MEMORANDUM

TO: Atlanta Urban Design Commission
FROM: Matt Adams, Executive Director
ADDRESS: 1163 Wilmington Avenue
APPLICATION: CA2-23-323
MEETING DATE: December 13, 2023, deferred since October 11, 2023

MEMORANDUM

TO: Atlanta Urban Design Commission
FROM: Matt Adams, Executive Director
ADDRESS: 378 Grant Park Place SE
APPLICATION: CA2-23-346
MEETING DATE: November 20, 2023

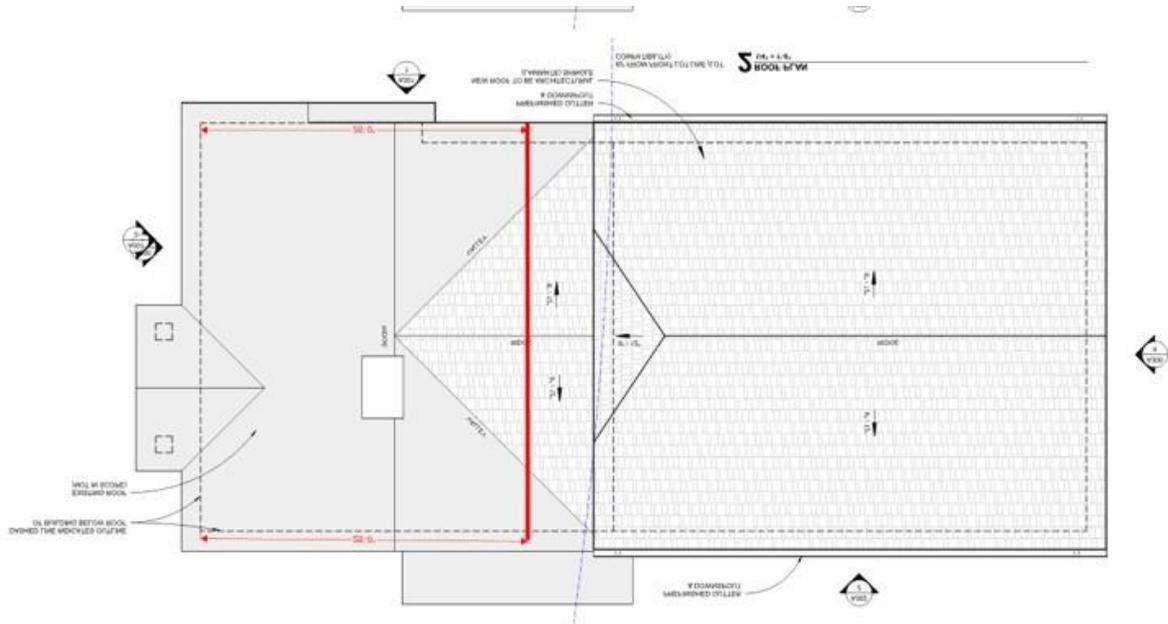
The Applicant selected the following houses for comparison because they are single family two-story houses:

- 998 Williams Mill
- 1000 Williams Mill
- 1008 Williams Mill
- 1017 Williams Mill
- 1036 Williams Mill
